Southern Nuclear Operating Company
Vogtle Electric Generating Plant Unit 3
Preliminary Amendment Request (PAR): Changes to the Structures and Layout of the
Annex Building, Turbine Building, and Radwaste Building (PAR-12-004)

**Preliminary Amendment Request
Regarding Changes to the Structures and Layout of the
Annex Building, Turbine Building, and Radwaste Building
(PAR-12-004)**

**Licensing Basis Documents - Proposed Changes
(Publicly Available Information)**

Figure 9.4.8-1

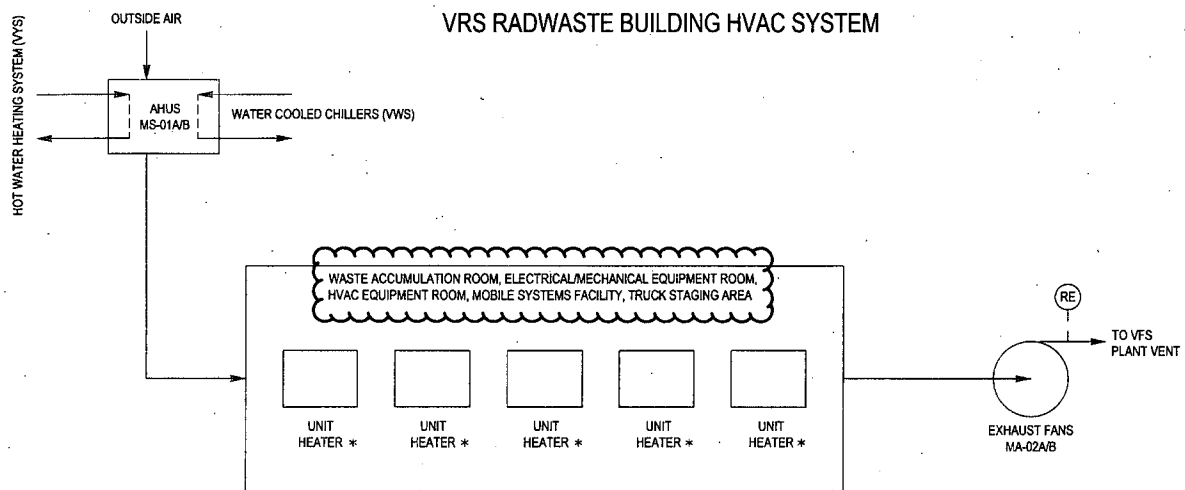
Tier 2, Section 9.4.8
“Radwaste Building HVAC System”

Revise the first paragraph, as follows:

The radwaste building HVAC system serves the radwaste building which includes the clean electrical/mechanical equipment room and the potentially contaminated HVAC equipment room, ~~the packaged waste storage room,~~ the waste accumulation room, and the mobile systems facility.
